Meeting Date:
 November 18, 2024

Location:
 Darrow Road

Request:
 Major Site Plan -Preserve
 of Hudson

Hudson Planning Commission	MAJOR SITE PLAN REVIEW
Case No. 2024-1186	November 18, 2024

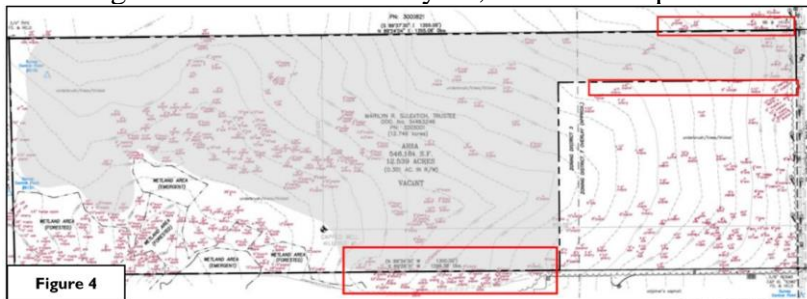
- The submitted trip generation analysis shall be updated to clarify the anticipated number of AM and PM peak hour vehicle trips.

Staff Comment: Acceptable. The applicant has revised the trip generation analysis to include the anticipated AM and PM peak hour vehicle trips per the following.

The report also analyzed sight distances for the proposed drive connection at Darrow Road. The conclusions of the report state the anticipated number of trips would have an insignificant impact on traffic operations along Darrow Road and the proposed sight distances exceed the ODOT requirements for intersection sight distance (ISD). The Assistant City Engineer has reviewed and accepted the analysis.

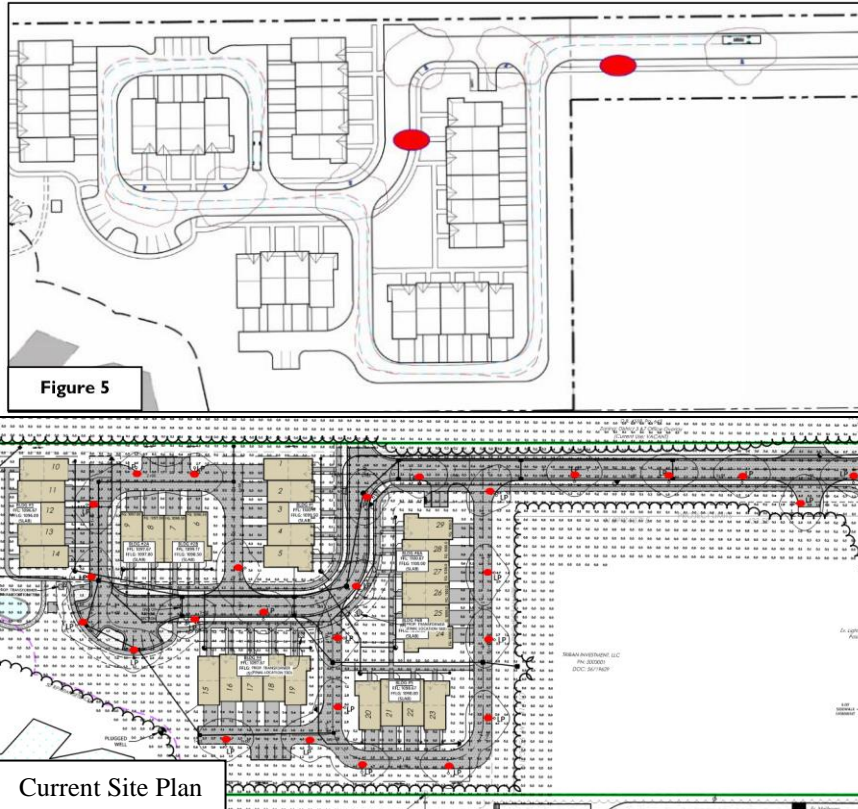
- Revise the plans to set back the limits of disturbance along the areas highlighted in Figure 4 of this staff report (May 13, 2024) to protect trees on adjacent parcels.

Staff Comment: Acceptable. Staff notes the applicant has modified the limits of disturbance within the areas highlighted in the figure below from the May 13, 2024 staff report.

1. Protective fencing shall be installed around existing trees located near the proposed clearing limits as depicted in Figure 2 of the staff report.
2. The Landscaping Plan shall be revised per the following:

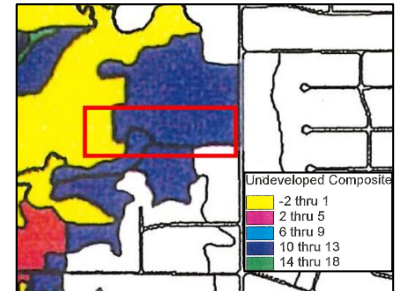
Priority areas for retention of existing trees and vegetation shall include, but not be limited to riparian areas, wetlands, wildlife habitat, aquifer or wellhead protection areas, areas falling within the two highest quality ecological integrity classifications for any of the individual metrics or composite as set forth in Appendix B to this Code, and other sensitive natural areas. Streets, buildings, and lot layouts shall be designed to minimize disturbance to all trees nine inches DBH or larger.
Staff Comment: Acceptable. Staff conducted a field visit and reviewed the proposed Tree and Vegetation and notes the following:

- The previous owner routinely cleared portions of the site to maintain a network of paths. Therefore, there is an absence of mature trees onsite considering the 12.5-acre lot size. The result is an abundance of underbrush trees.
 - A small cluster of mature trees (highlighted on page 8 in red) is proposed to be removed; however, the City Arborist notes many of these trees include undesirable species such as Poplar and Thorn Apple. Two other clusters of mature trees were identified (highlighted on page 8 in green). These mature trees would be preserved. The largest of

these clusters are located within the identified forested wetlands and would be preserved.

- The Index of Ecological of Integrity identifies areas of high composite scores onsite; however, staff anticipates this is primarily due to the presence of wetlands. Staff notes the generalized EI index data is not accurate to this site as the site contains wetland areas worth protecting at the southwestern portion of the site; however, the index notes this area as lower quality than the largely scrub brush/wooded area on the remainder of the property. Staff recommends relying more on the site-specific wetland delineation and field observations above, which identifies specific locations of wetlands and current conditions, when reviewing this requirement.
- The applicant shall install silt fencing and/or polypropylene fencing to mark and protect the approved clearing limits, which shall be maintained by the applicant.

7. The City Solicitor shall approve the Declaration of Condominium Ownership prior to a zoning certificate being issued.
8. The applicant shall install silt fencing and/or polypropylene fencing to mark and protect the approved clearing limits, which shall be maintained by the applicant.

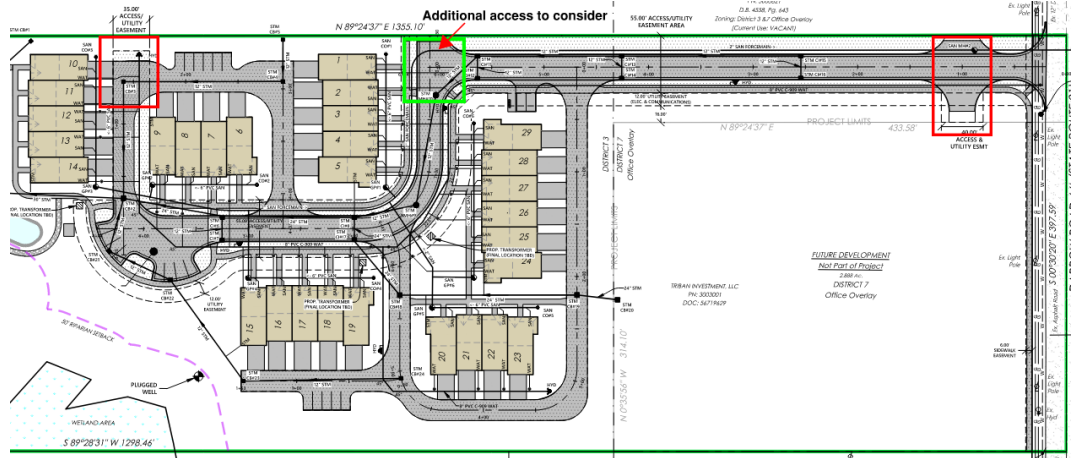
Staff Comment: Staff notes the applicant is proposing two shared access and utility easements. One would be located towards the front of the property and would align with the SR-91 Traffic Corridor Study. The other would be located towards the rear of the property. Staff recommends these access easements be extended to the northern property lines and recorded prior to the issuance of a zoning certificate. Additionally, staff recommends a third access easement be established to the property to the north as depicted on page 12.

4. Access easements shall be recorded, subject to the acceptance of the City Engineer, prior to the issuance of a zoning certificate. Access easements shall extend to the northern property lines. An additional access easement shall be included along the drive in front of the building containing units #1- #5.
